SUBJECT: Design Review Response Letter for SUBFY2026-0002

Attached please find the updated Schematic Design Drawings incorporating the following changes per the Design Review Meeting on July 20th.

1 ARCHITECTURAL SITE PLAN
1" = 10'-0"

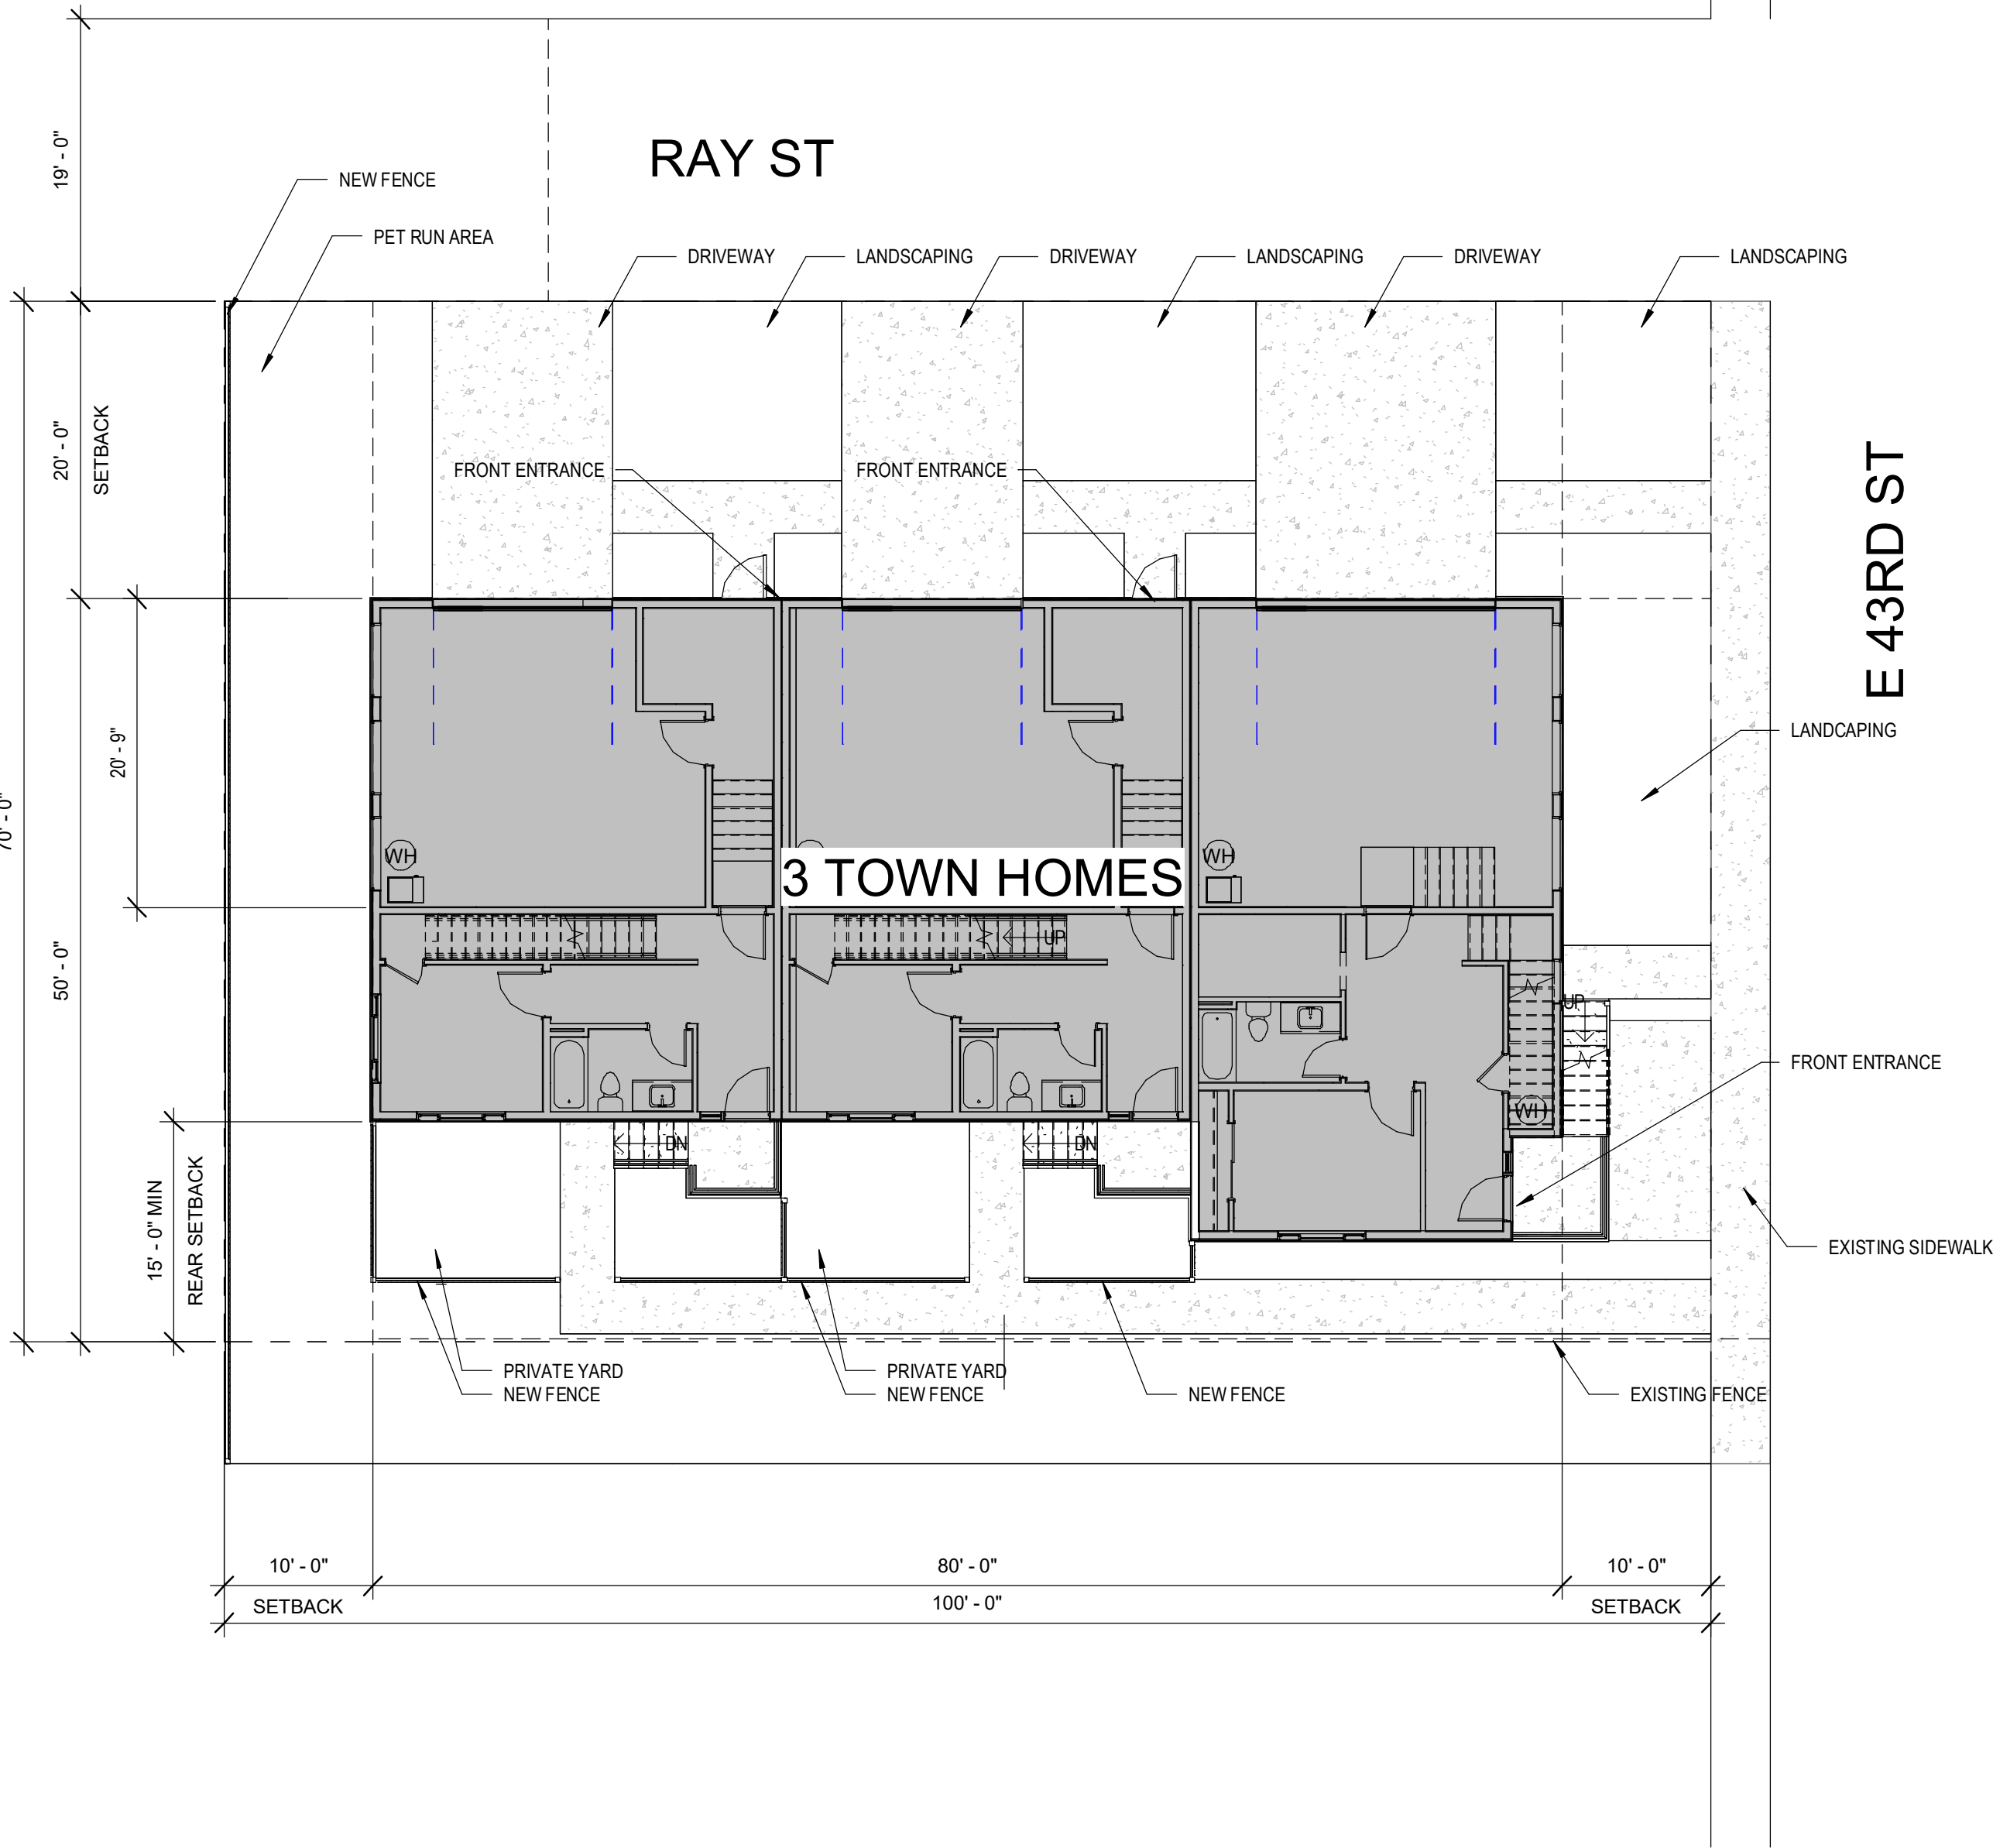
- The two units on the west side have been reduced in area to provide a 15' rear setback.
- An enclosed main entry on the north side has been added to the two units on the west side.
- Private yards have been added to the two units on the west side.
- Every level has been reduced in area and reconfigured for the two units on the west side.

Upon further review of Garden City's Municipal Code, the original design as presented is code compliant and should not require the changes requested by the Design Review members.

Section 8-2B-3 G.5 Structures that contain more than one dwelling or nonresidential tenant, or combination thereof shall be considered as one building for the purpose of determining front, side and rear yard setbacks.

The unit facing 43rd St clearly defines the front of the building in compliance with Section 8-4C-3 A.2 and A.5. One building will be constructed containing three individual units in compliance with Section 8-2B-3 G.5. We respectfully request approval of the initial design as submitted with the following revisions:

- Inclusion of Pet Run Area as a Class B amenity
- Addition of small Pedestrian plaza facing 43rd St with a park bench
- Additional glazing as provided with second submittal
